NULU Review Overlay District

21-OVERLAY-0010

900 E Market Street

PROPOSED NORTHWEST VIEW

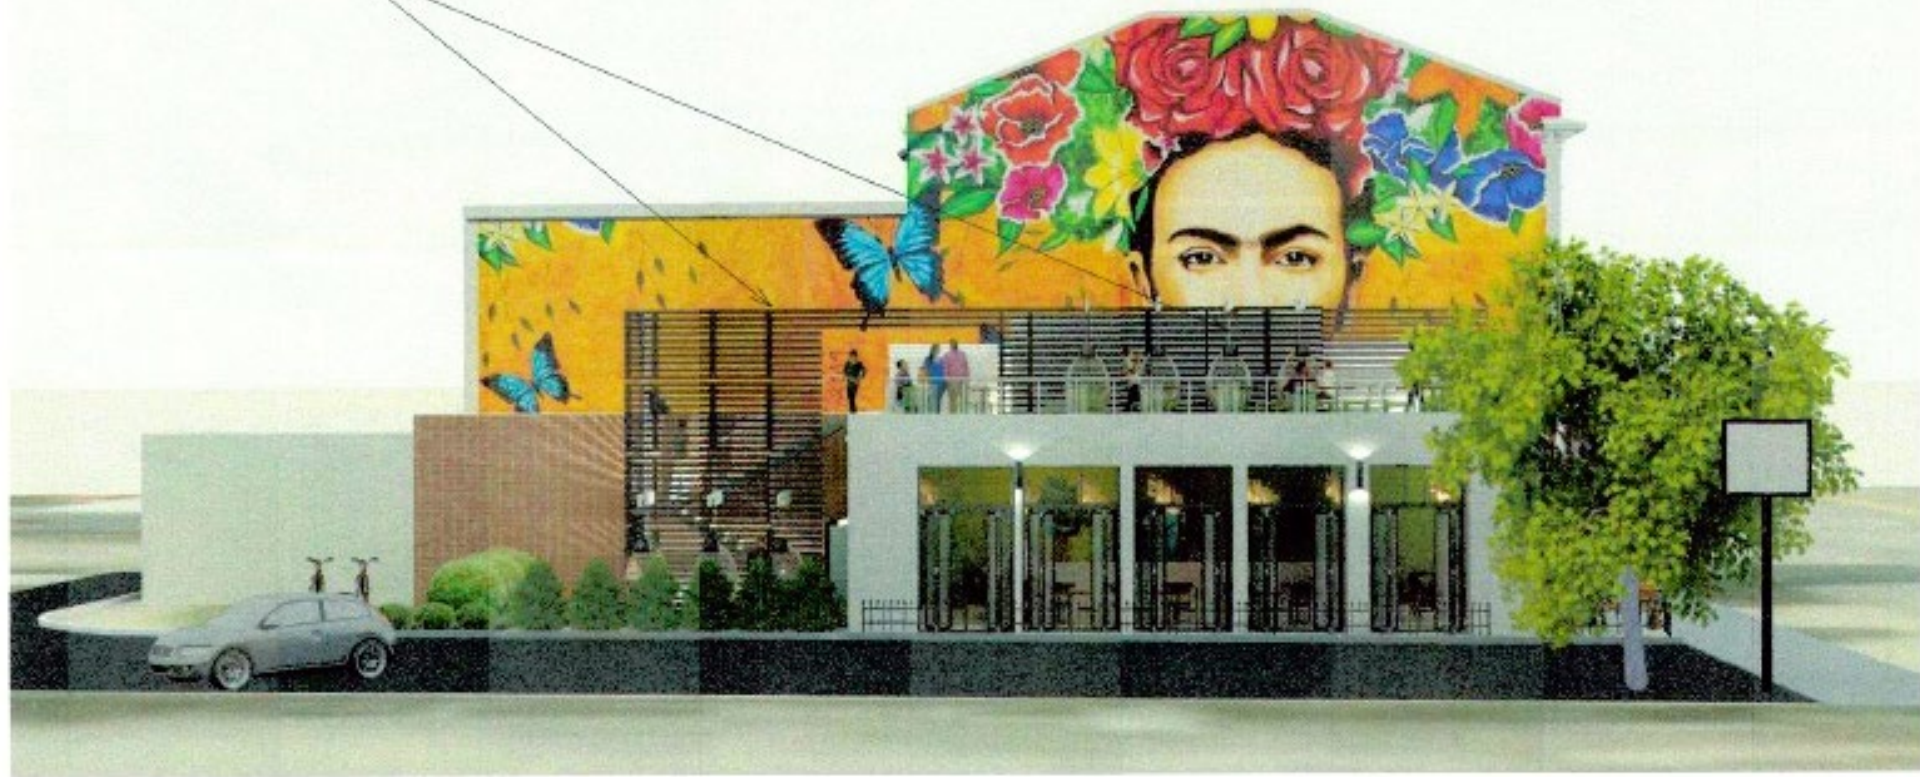
PROPOSED NEW SIGNAGE
OVER EXISTING

1. The proposed attached signage complies with the guidelines in general concept. Final signage details as well as any additional signage proposed in the future shall comply with the Signage Design Guidelines and be submitted to staff for final review and approval.
2. Public art shall be designed, executed, and supervised by recognized artists or other design professionals who have been trained or have consistently provided examples of artistic work in their medium of expression.
3. Environmentally sustainable elements shall be incorporated into the project as much as possible.
